Access Compliance Report

Public Rights-of-Way

(Curb Ramps)

| Intersection ID: 54151 | Main Street: SANDERS_FARM_LN | Cross Street: WALNUT_FOREST_DR | Location: SW |

| ADA ID: 91EF6A6113B0 | Ramp Type: Perp | Initial Pass/Fail: Fail | Overall Compliance: No |

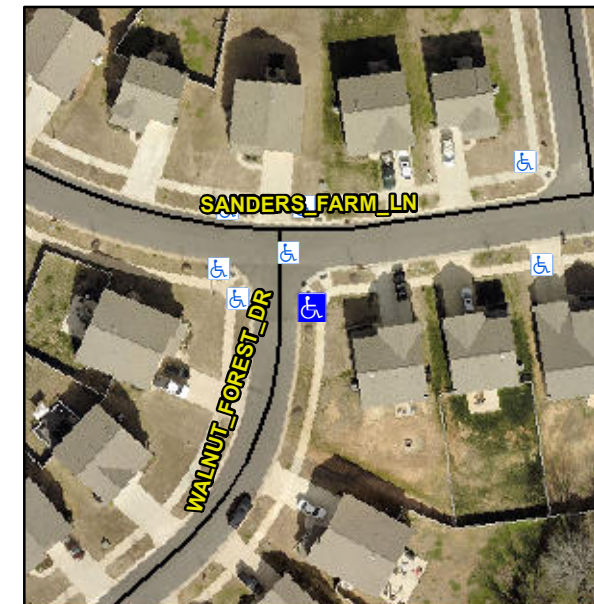
Remove & Replace Entire Ramp.

Not Found, R304.5.1, R304.2.2, R304.5.3

| Compliance | Description | Data | Compliance | Description | Data |
|------------|-----------------------|------|------------|-----------------------------|------|
| N/A | Ramp Length (in) | 96.0 | No | Ramp Slope (%) | 8.5 |
| No | Ramp Width (in) | 46.0 | No | Ramp XSlope (%) | 2.4 |
